Notice of Meeting of the Historic and Architectural Review Commission of the City of Georgetown, Texas March 11, 2026

701 S. College (2026-7-COA)

The Dunn Residence
A New Custom Home @ 701 S. College Street,
Georgetown, Williamson County, TX

File Number: 2026-7-COA

FRONT ELEVATION

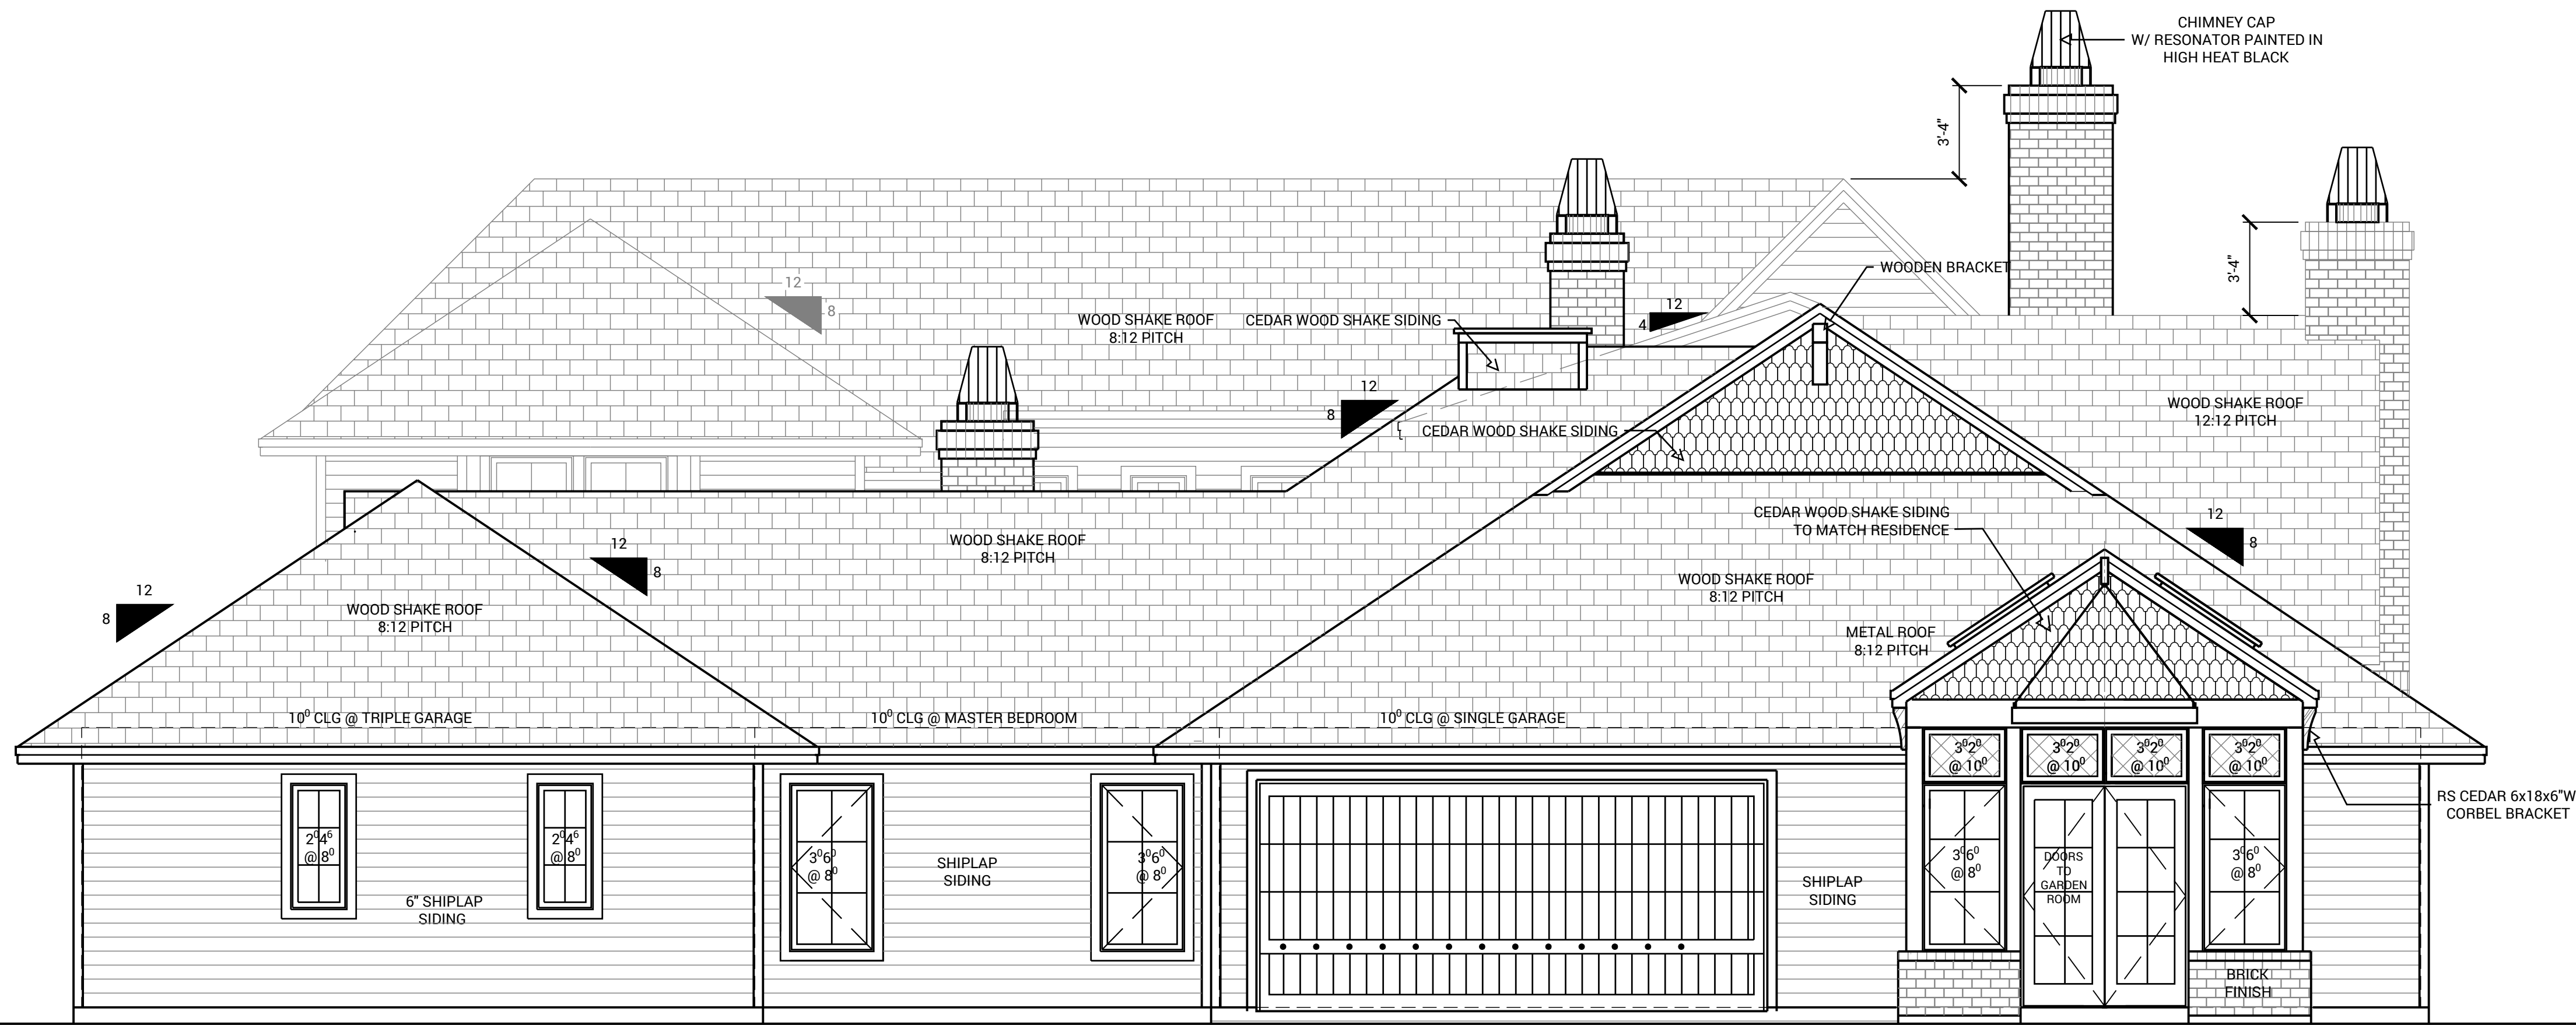
a. The main mass form should be a simple square, a rectangle or an “L-Plan” with an uncomplicated roof form, that is having a minimum of roof plane changes.	Partially Complies The proposed structure has a U-shaped form proposed, as the home is centered around a pool and courtyard in the rear of the structure. The proposed roof form consists of overlapping gables and cross gables that include several roof plane changes throughout the proposed design. Two of the street views do provide rectangular views of the home with the U-shape is only seen from the rear of the home.

b. The proportions of the front façade should be taller than it is wide.	Does Not Comply The proposed home is approximately 74'-8" wide and 29'-7" tall, meaning that is more than twice as wide than it is tall. Considering the size of the lot this would be a difficult guideline to fully comply with. There are other homes that are wider than they are taller that became this way due to previous HARC approvals.

a. Windows should generally comprise 30-45% of the front façade.	Complies Windows comprise 30.5% of the front façade. The overall front façade, excluding the roof area is approximately 1,293 square feet and the total window area is 395 square feet.
